# Expert Opinion

## Amendment C363 to the Greater Geelong Planning Scheme

McLeods Developments Pty Ltd

August 2020

Figure 6-3 Preliminary 1% AEP Flood Modelling Results Extent (source: Water Technology 2016)

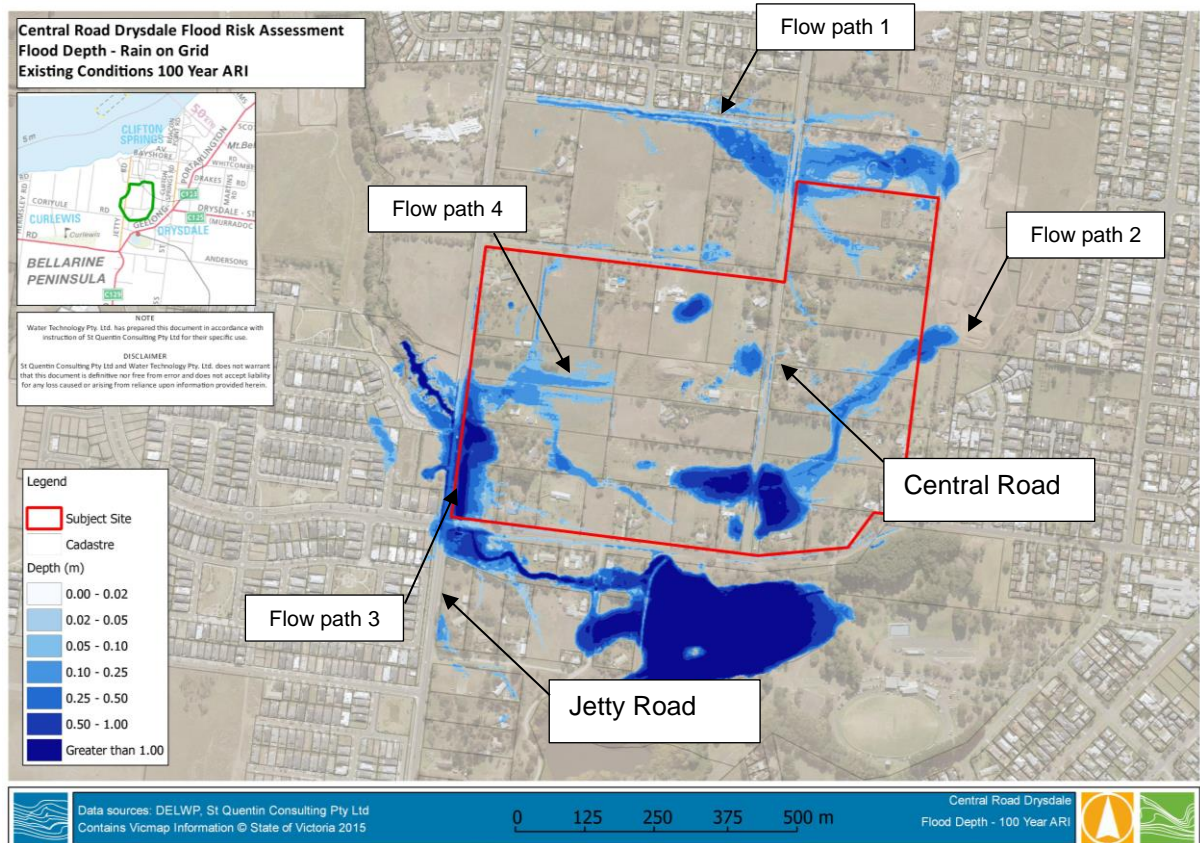
There is a significant overland flow path (Flow Path 3 shown on Figure 6-3) that passes through the south-west corner of the site. The CCMA indicated that the development layout must maintain conveyance capacity of this flow path. As a result, a minimum 30 m buffer was nominated for public open space east of Jetty Road to:

- Maintain conveyance capacity and the drainage function of Flow Path 3 (Griggs Creek); and
- Maintain/enhance landscape values of the existing drainage corridor.

Figure 7-2 Upstream Catchment Delineation

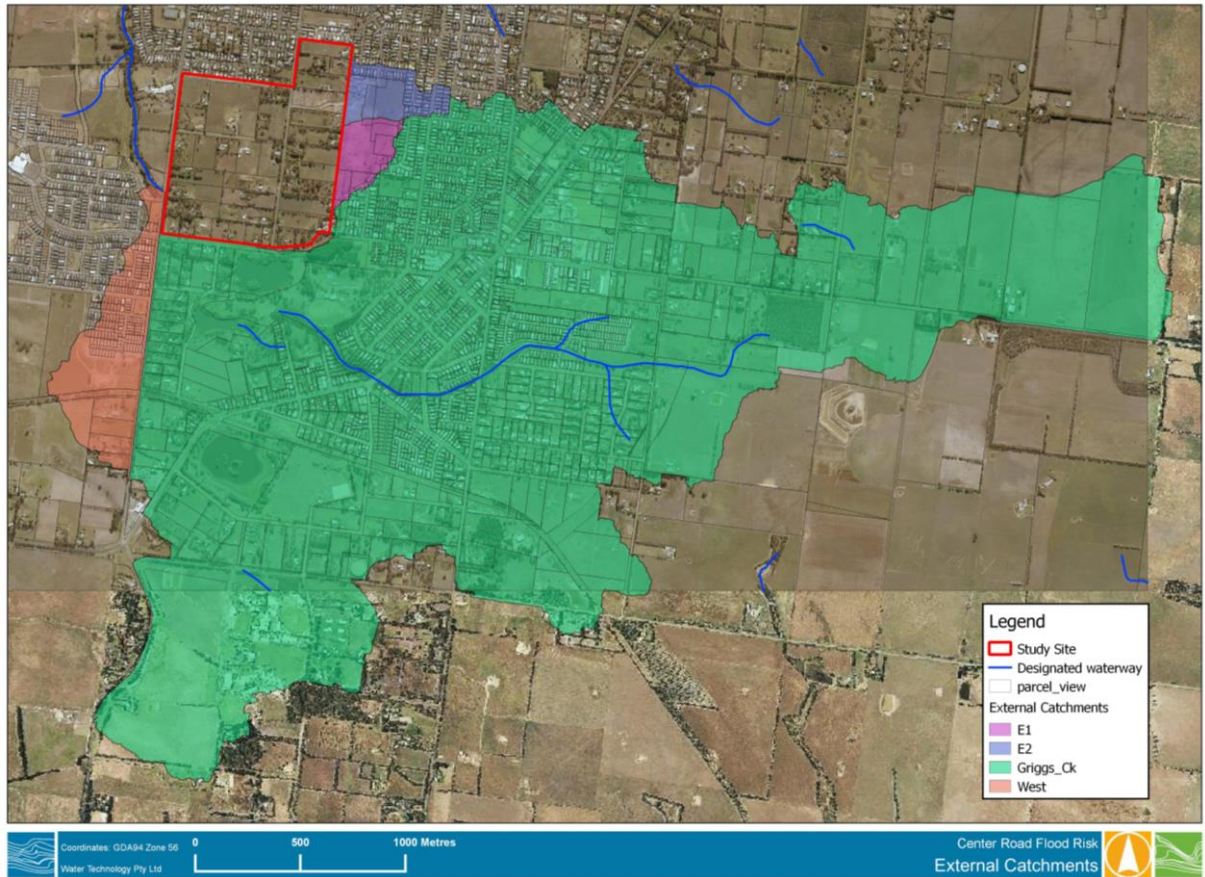
Part of the catchment areas for flow paths 1 and 2 are located east of the subject site. These external catchment areas are identified in the May 2019 Stormwater Management Report (Figure 3-1 of that report and reproduced as Figure 7-2 below). These external areas were not included in the hydrological modelling for the retarding basin designs in the Water Technology report for the reasons set out below:

- The external catchment area designated E2 in Figure 7-2 is mostly covered by an existing special charge scheme (see Figure 7-1) for drainage purposes. This area was therefore excluded from the analysis as future drainage infrastructure in this area, along with the natural topography, will direct flows away from the subject site. Figure 7-3 shows the relationship between the site, the external catchment areas (east of the site), the Sheileen Land and Special Charge Scheme;
- The eastern properties known as the Sheileen Land (within catchment E1 in Figure 7-2, namely 1 Sheileen Court, 2-20 Sheileen Court and 23 Marsh Court) are already zoned for residential development and not part of the DCP area. Hence it was assumed that they are not intended to be treated by the proposed water management measures for the DCP.

Previous catchment flood analysis showed that the Sheileen Land is within External Catchment E1. These properties are therefore likely to contribute to Flow Path 2 within the subject site, albeit to a minor degree. For this reason, I believe External Catchment E1 should be included in the RORB modelling for the retarding basins. I note that, as described above, I believe the retarding basins are not required to mitigate developed flows from this area.

In order to assess how the two proposed retarding basins would behave, allowing for the additional runoff from the external catchment, I have undertaken additional hydrological modelling. The analysis is independent of the water modelling in the previous reports but did make use of the existing RORB model for the site and wider catchment. Two scenarios were tested:

- 1) Greenfield (existing) conditions are assumed for the external catchments with flows directed towards the two retarding basins.
- 2) The area is assumed developed with 2.9 ha of the external catchment directed towards the two proposed retarding basins, with the remaining areas diverted away as part of the northern Special Charge Scheme.

The first scenario provides an assessment of the performance of the two retarding basins against existing conditions, assuming Catchment E1 (about 8.3 ha) is undeveloped and Flow Path 2 is maintained through to the proposed retarding basins.

The second scenario allows their performance to be assessed with the Special Charge Scheme in place, allowing for some conservatism in the assumptions, including:

- The external area draining to the two retarding basins (the Sheileen Land) was considered to be developed (fraction imperviousness of 45% representing traditional residential development, compared to 20% under existing conditions); and
- No mitigation measures (i.e., retarding basin or on-site detention) were allowed for in the Sheileen Land.

The modelling shows post-development flows at Jetty Road do not exceed the adopted maximum permissible site discharge (existing conditions design peak flow), for both scenarios. It is noted that pre-development flows would be notionally larger if allowing for the external catchment area, east of the site. Furthermore, flood storage volumes for the Jetty Road retarding basin were comparable to those reported in the previous reports.

Although flood storage (and 1% AEP design flood levels) increases in the retarding basin east of Central Road, any impact on flood risk could be mitigated either by minor modifications to the design such as changes to the outlet. The hydrologic modelling suggests the proposed retarding basin system retards stormwater runoff to pre-development levels downstream of the subject site (west of Jetty Road), allowing for runoff from the Sheileen Land.

It will be necessary to maintain an overland flow path between the eastern properties and the overall site, to allow Flow Path 2 to be conveyed post-development. A pedestrian pathway could readily act as a designated overland flow path to safely convey flood flows. I note that a road connection is shown on the development plan (see Figure 6-4). According to the Council Minutes of 28 January 2020 Council now supports the removal of a road connection between Marsh Court and the subject site in preference to a pedestrian-only link. Accordingly, land will be set aside as a pedestrian, bicycle and drainage link. This link can act as a designated overland flow path for runoff from the Sheileen Land and could be designed to safely convey overland flow. This overland flow path should be incorporated to connect the Sheileen Land to the retarding basins, as the removal of the existing flow path would detrimentally impact the drainage of 1 Sheileen Court, 2-20 Sheileen Cort and 23 Marsh Court.

Based on the above, I consider that the retarding basins are appropriately sized. There will also be opportunities to further optimise their design during the detailed design stage. Appropriate performance standards are a requirement of the planning scheme, however any particular concerns can be addressed through requirements for the development plan. I have reviewed the proposed Schedule 37 to Clause 43.04 Development Plan Overlay and consider the requirements to be generally appropriate. A requirement should be added to ensure an overland flow path is maintained from the eastern properties under DDO 43.

Figure 7-4 Water Surface Elevation Difference Plot between Existing and Developed Conditions (1 hour)

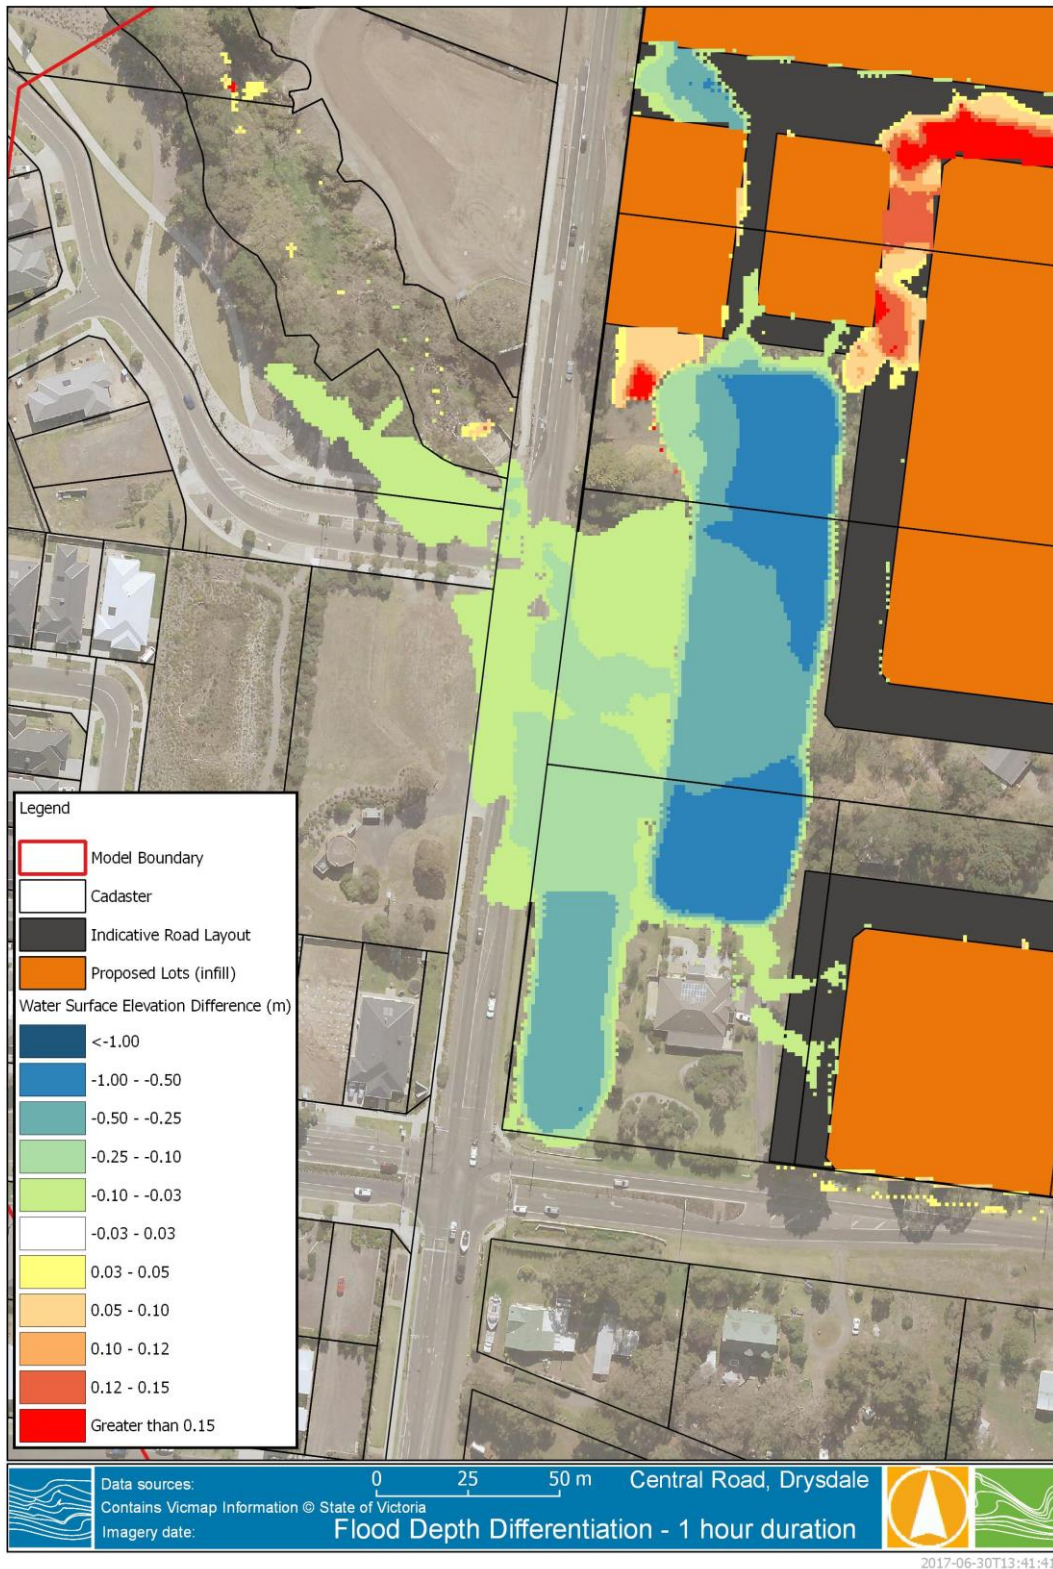
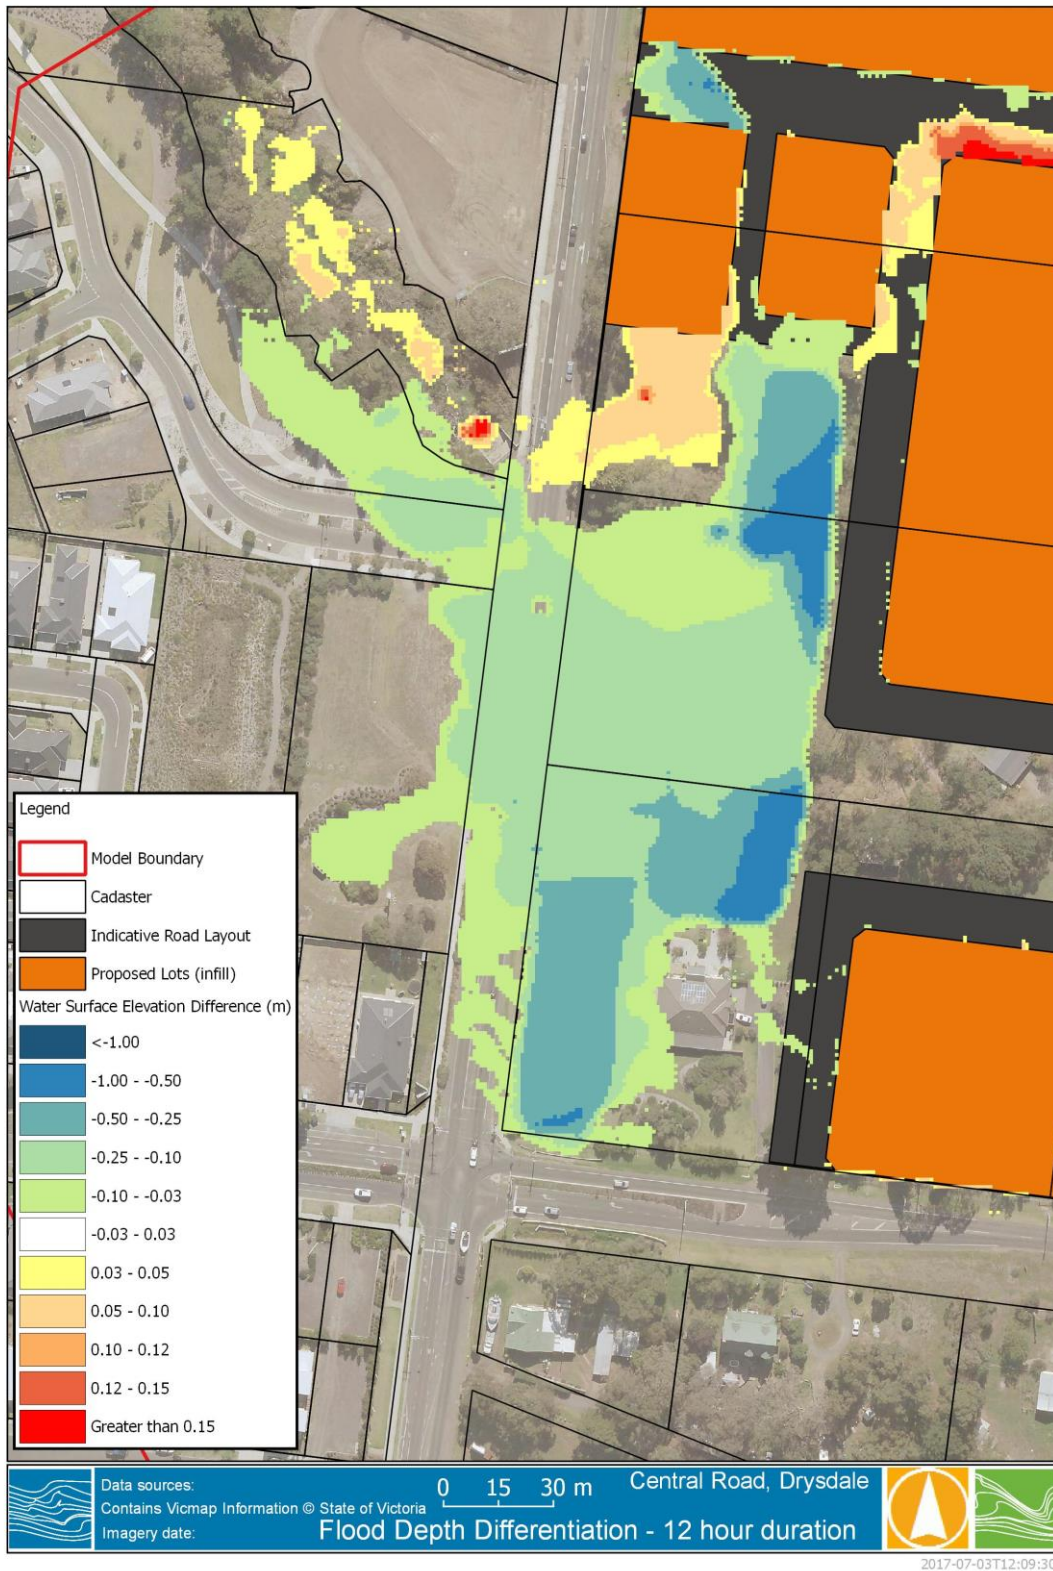
Detailed hydraulic modelling of the 1% AEP design flood was completed for existing and proposed conditions. The results from both scenarios were compared to determine if the proposed development has the potential to alter flooding through the areas adjacent to, upstream or downstream of the subject site. This type of analysis is consistent with industry best practice.

As required by the CCMA, the development should not divert floodwaters or increase flood levels to the detriment of adjoining properties. Whilst the proposed development results in localised afflux for the 1% AEP design flood (1 hour and 12 hour duration storms), the proposed drainage system and retarding basin result in a reduction in flood depths along Flow Path 3 and, importantly, in an adjacent property. Any afflux (increase in flood levels due to the amendment) is limited to road infrastructure and the waterway and, given the reduction in flood depths observed elsewhere, the proposed stormwater strategy provides an improvement compared to the existing conditions. This is illustrated in Figure 7-4 and Figure 7-5. These show the difference in peak 1% AEP design flood depths for the 1 hour and 12 hour duration design storms respectively. Areas that are blue and green represent a reduction in flood depth compared to existing conditions (improvement). Areas that are red and yellow represent an increase in flood depths (detriment). Areas within the subject site are not of significant concern with respect to changes in flood depth as revised ground levels as part of future development will accommodate for any changes compared to existing conditions.

The flood model also confirmed that:

- The development layout maintains conveyance capacity of Flow Path 3;
- There is no net loss of flood storage within the site;
- Peak post-development flow rates do not exceed the pre-development discharges for the 1% AEP design storm; and
- All new lots are filled and outside the post developed mapped 1% AEP design flood extent.

Whilst hydraulic modelling showed localised afflux for the 1% AEP design flood (1 hour and 12 hour duration storms), the proposed drainage system and retarding basin would generally result in reduction in flood depths along Flow Path 3 (Griggs Creek). Additionally, this afflux is limited to road infrastructure and the downstream waterway and does not impact on flood depths on downstream properties. Flood hazard is generally reduced within the site and along Jetty Road.

Figure 8-1 Proposed Constructed Wetlands and Retarding Basins – Overall Plan

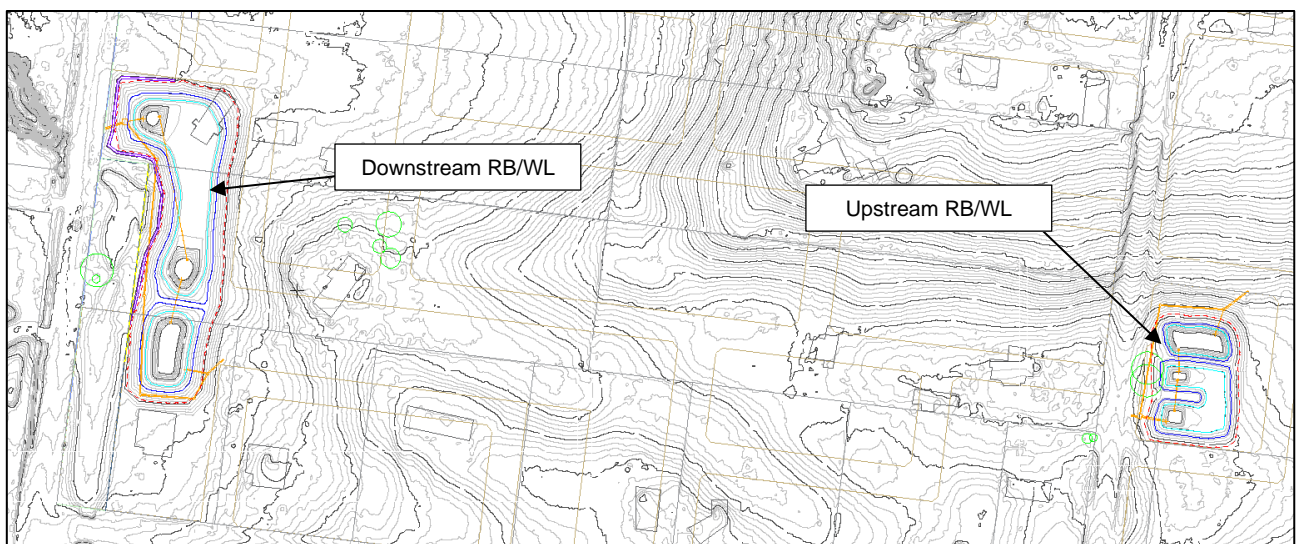
Any differences between the overall design values presented in the Stormwater Management Plan and the Wetland Functional Design Report is due to the refinement of the design at the functional stage, noting that:

- The hydrological RORB model was updated, to reflect revised asset design and confirm that the peak post-development flow rates do not exceed the pre-development discharges for the 1% AEP design floods;
- Water quality analysis was conducted in MUSIC, noting that asset footprints generally match those reported in the Stormwater Management Plan and Best Practice targets are therefore met; and
- The Functional Design Report provides additional details relative to:

- The retarding basin/wetland immediately upstream (east) of Central Road (as shown in Figure 8-1) may be constructed as a standalone asset, to service the area east of Central Road (about 9.5 ha);
- A smaller interim basin immediately upstream (east) of Jetty Road may also be constructed as a standalone asset. This, in conjunction with the Central Road Retarding Basin/Wetland, could service up to 25.5 ha (including the 9.5 ha east of Central Road) during the interim stage (see below).

Figure 9-1 Interim Jetty Road Retarding Basin/Wetland

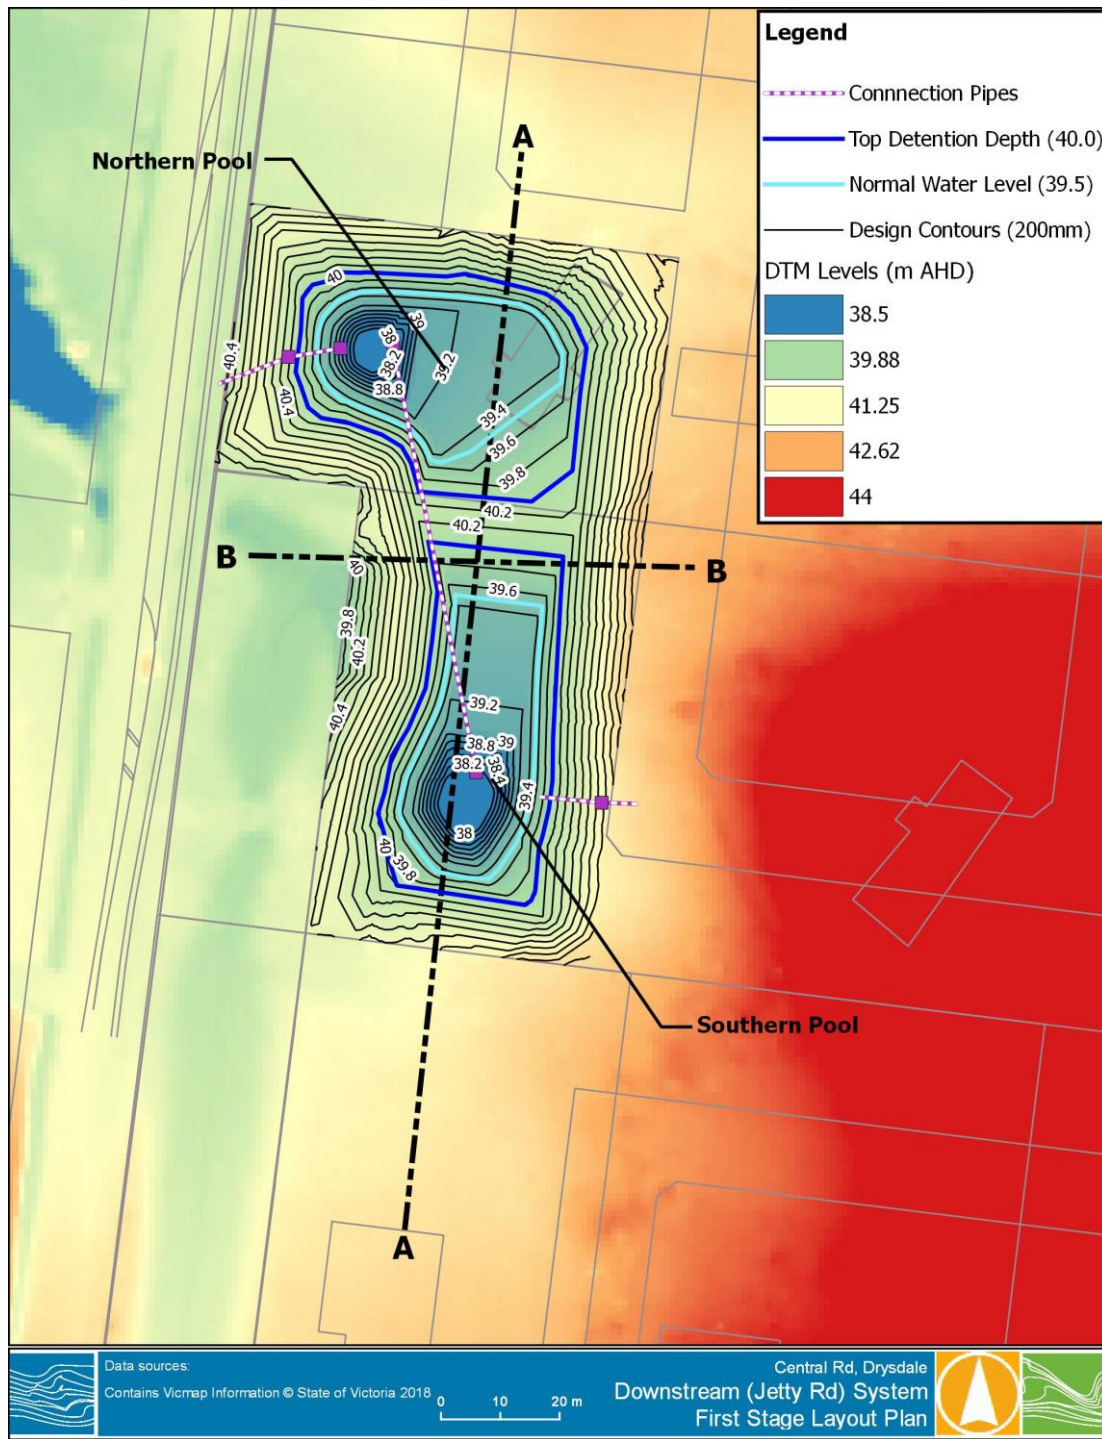
- The interim basin would be constructed on 171 and 161 Jetty Road only, as those parcels are currently owned by the proponent, McLeods Developments Pty Ltd, with no work to occur on 164-168 Wyndham Street (see Figure 9-1):
  - Up to 16 ha (between Jetty Road and Central Road as shown in Figure 9-2) may be serviced by the Jetty Road wetland/retarding basin, if constructed as a standalone asset (i.e., no asset east of Central Road); or
  - Up to 25.5 ha (over the entire site) if the wetland/retarding basin immediately upstream (east) of Central Road is also constructed (that is an additional 9.5 ha east of Central Road).

The design of these assets will need to tie into the surrounding design levels, including future development roads and parcels to the north and east.

This is likely to be beneficial from a water quality perspective as it would minimise the risk of the proposed treatment wetland receiving insufficient inflows during the early stage of development.

The interim arrangement also allows for the excavation and construction of the temporary sedimentation basin, and the wetlands being fully planted later, when sediment loading from the upstream catchment would not result in adverse impacts: The critical driver of stormwater treatment in constructed wetlands has been found to be the proportion of Emergent Aquatic Vegetation within the macrophyte zones. Excessive sediment may damage macrophyte vegetation and thus compromise long-term treatment performance of a constructed wetland.
